Re: Proposed Sampling Request
Jones D Tank Battery
API No. 30-015-00192
GPS: Latitude 32.7506142 Longitude -104.3300247
UL "H", Sec. 13, T18S, R26E
Eddy County, NM
NMOCD Ref. No. NMLB1401534243, nRM2008547914

From: [Hall, Brittany, EMNRD](#)
To: [Katherine Purvis](#)
Cc: [Braidy Moulder](#); [Chris Jones](#)
Subject: RE: [EXTERNAL] Jones D Sampling Plan, revised
Date: Friday, April 4, 2025 1:48:00 PM
Attachments: [image001.png](#)

The Jones D Sampling Plan is approved with the following conditions:

Jones D Tank Battery
API# 30-015-00192
Eddy County, NM
Sampling Map

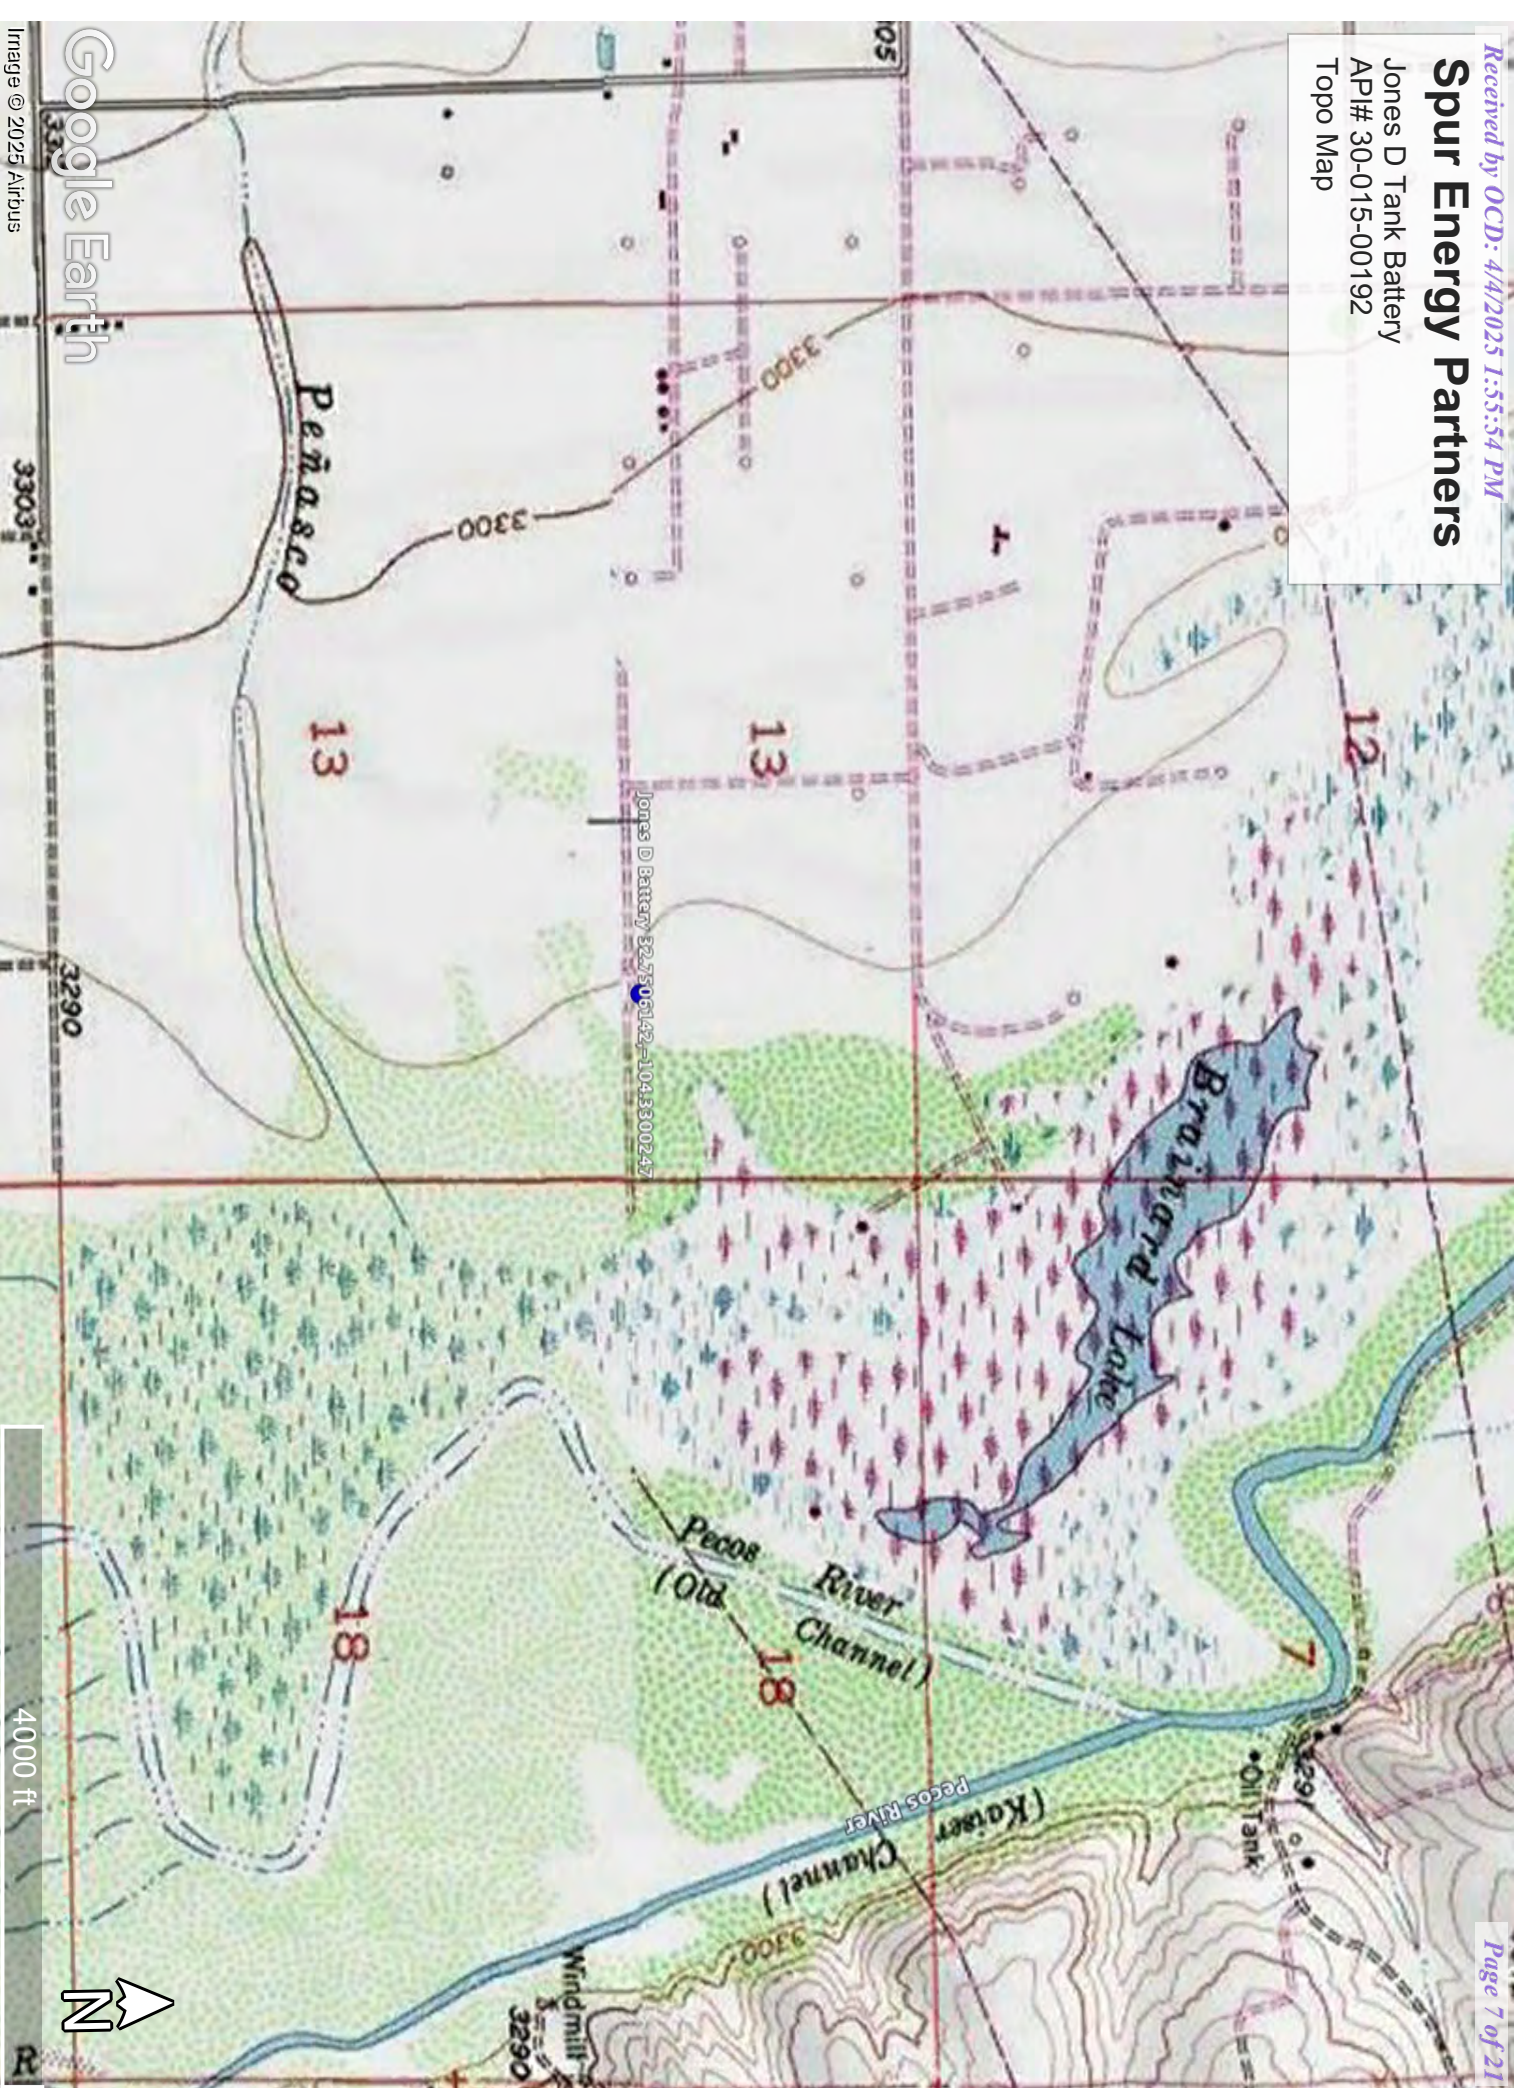
- The site must be delineated to the most stringent closure criteria found on Table I of 19.15.29 NMAC. If delineation is not achieved at the depths or the proposed locations found on the Sampling Map, deeper samples than what is proposed and additional horizontal delineation samples must be collected until full horizontal and vertical delineation is achieved.

- Be advised that OCD does not have any record of an 18 feet deep excavation or delineation that took place in 2020. Additional delineation past the depth of 18 feet may still be warranted if sample results show contamination has not been delineated deeper than 18 feet.
